HUNTINGWOOD WEST PRECINCT – BUNGARRIBEE INDUSTRIAL ESTATE

PROPOSED SECTION 75W MODIFICATIONS TO MP06_0203 AND MP08_0225

PREPARED FOR GOODMAN
NOVEMBER 2012

FIGURE 7 – GEOGRAPHIC EXTENT OF MODIFICATIONS

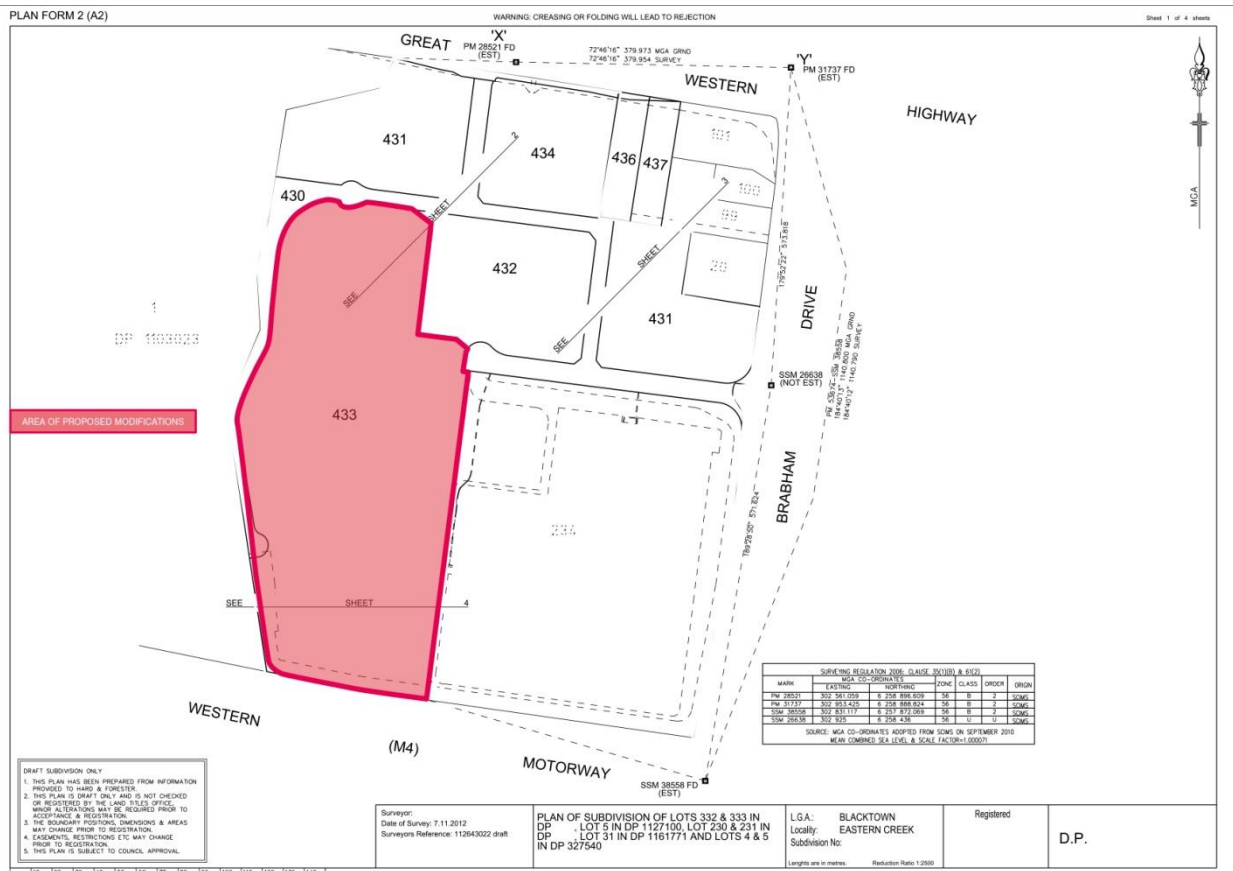
Accordingly, the modifications are proposed for works on land as shown highlighted on the plan at Figure 7.

FIGURE 12 – PROPOSED SUBDIVISION LAYOUT

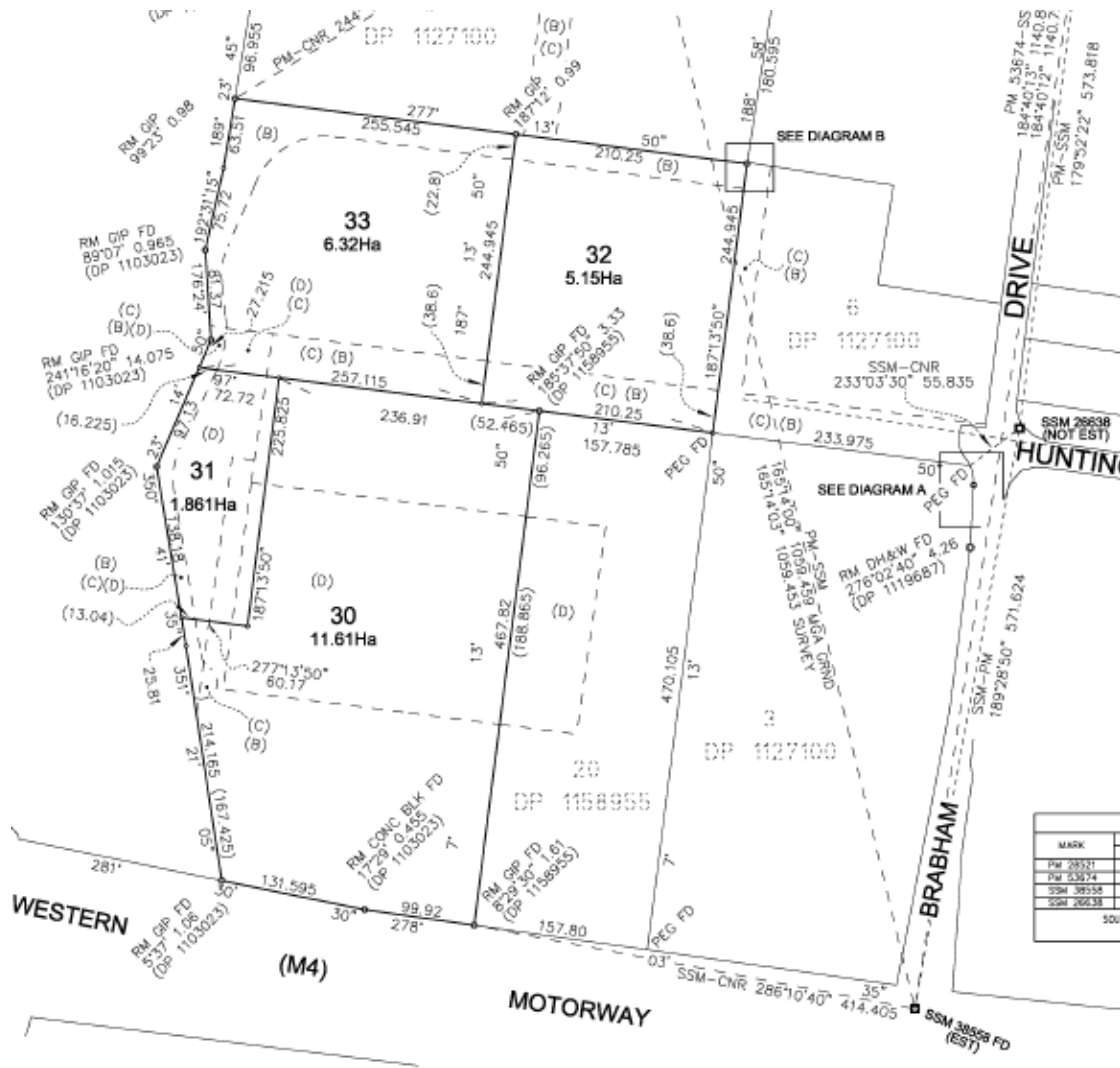
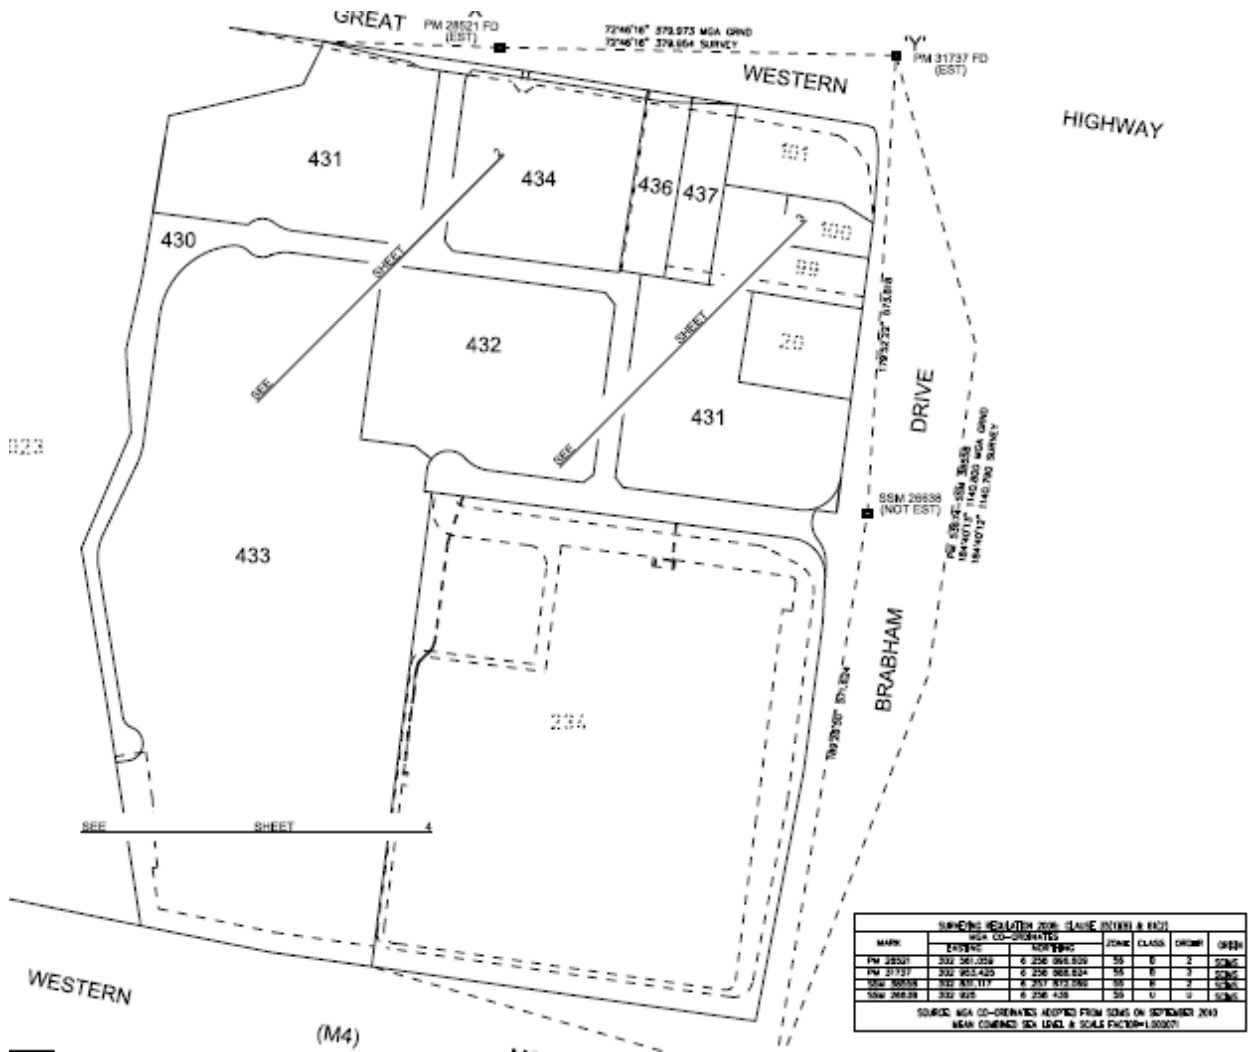
The revised site layout is shown on plan entitled “*Plan of Subdivision of Lots 332 & 333 in DP , Lot 5 in DP 1127100, Lot 230 & 231 in DP , Lot 31 in DP 1161771 and Lots 4 & 5 in DP 327540*” and shown at Figure 11 in this report. The plan proposes the following key changes:

- Reduction in length of the Huntingwood Drive roadway to the west; and
- Re-organisation of the development lots to provide an 18 ha allotment to accommodate the proposed freight transport facility (subject to separate approval by Blacktown City Council).

As part of the modification package, Goodman is seeking approval for the re-subdivision of the Estate to reflect the changes to site layout and accommodate the future proposed freight transport facility development. The proposed subdivision is illustrated in Figure 12 and detailed in Table 8 below:
